# PIC18F87J90 FAMILY

## PIC18F87J90 Family Silicon Errata and Data Sheet Clarification

The PIC18F87J90 family devices conform functionally to the current Device Data Sheet (DS39933D) except for the anomalies described in this document.

The following typographic corrections and clarifications are to be noted for the latest version of the device data sheet (DS39933D).

**FIGURE 2-3 FREQUENCY vs. ESR PERFORMANCE FOR SUGGESTED VCAP**

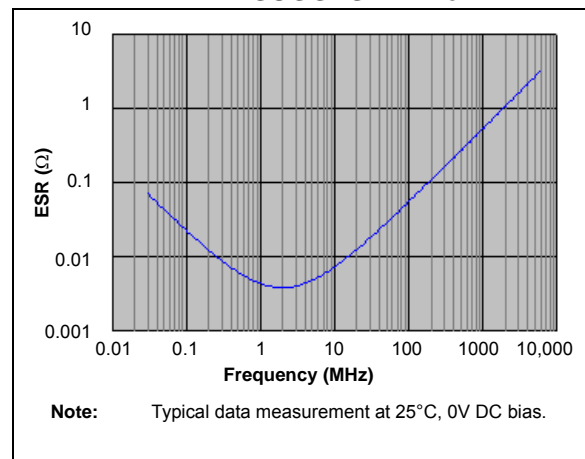
Section 2.4 “Voltage Regulator Pins (ENVREG and VCAP/VDDCORE)” has been replaced with a new and more detailed section. The entire text follows:

When the regulator is enabled, a low-ESR (< 5Ω) capacitor is required on the VCAP/VDDCORE pin to stabilize the voltage regulator output voltage. The VCAP/VDDCORE pin must not be connected to VDD and must use a capacitor of 10 μF connected to ground. The capacitor type can be ceramic or tantalum. Suitable examples of capacitors are shown in [Table 2-1](#). Capacitors with equivalent specifications can be used.

Designers may use [Figure 2-3](#) to evaluate ESR equivalence of candidate devices.

**FIGURE 2-4 DC BIAS VOLTAGE vs. CAPACITANCE CHARACTERISTICS**

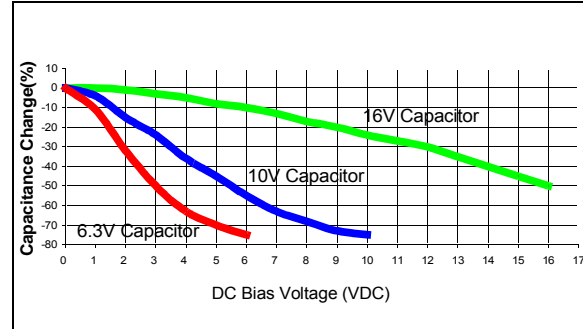
In addition to temperature tolerance, the effective capacitance of large value ceramic capacitors can vary substantially, based on the amount of DC voltage applied to the capacitor. This effect can be very significant, but is often overlooked or is not always documented.

Typical DC bias voltage vs. capacitance graph for X7R type and Y5V type capacitors is shown in [Figure 2-4](#).

When selecting a ceramic capacitor to be used with the internal voltage regulator, it is suggested to select a high-voltage rating, so that the operating voltage is a small percentage of the maximum rated capacitor voltage. For example, choose a ceramic capacitor rated at 16V for the 2.5V core voltage. Suggested capacitors are shown in [Table 2-1](#).
